TANC COMMENTS
ON THE CAISO'S DRAFT 2016-2017 TRANSMISSION PLAN AND FEBRUARY 18, 2017
STAKEHOLDER MEETING
MARCH 3, 2017

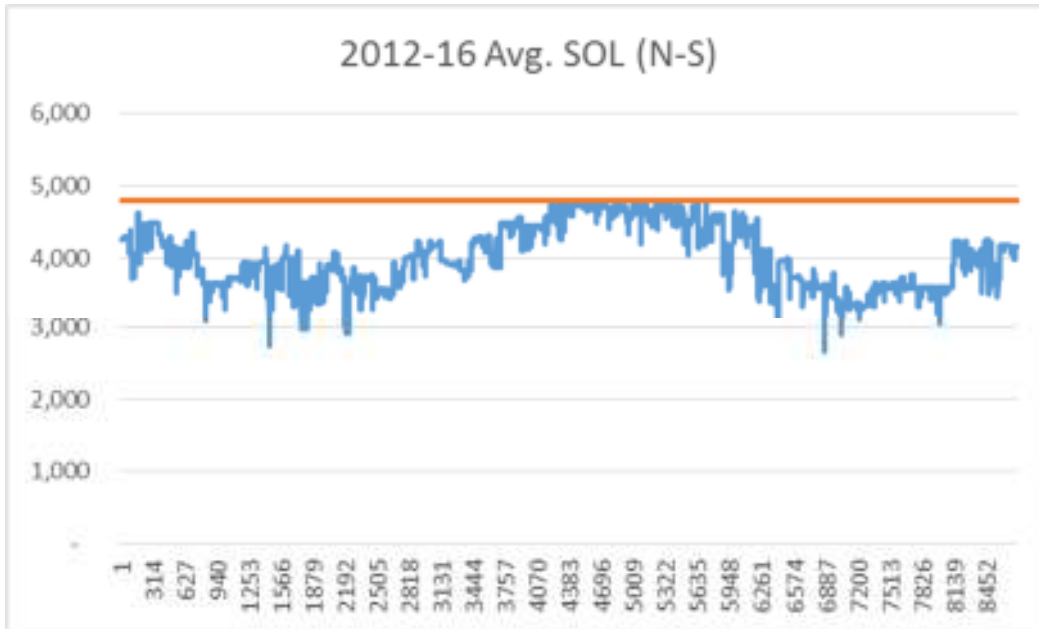
TANC has frequently made clear that the COI does not run at the capacity levels that are modeled in the CAISO economic studies. And while the expanded analysis in this year's cycle shows some limited reflection of the actual COI capability, the most recent analysis still comes far short of representing actual transfer capability available on COI. The following charts show the actual system operating limits (SOLs) on the COI from 2012-2016 and year-to-date for 2017.
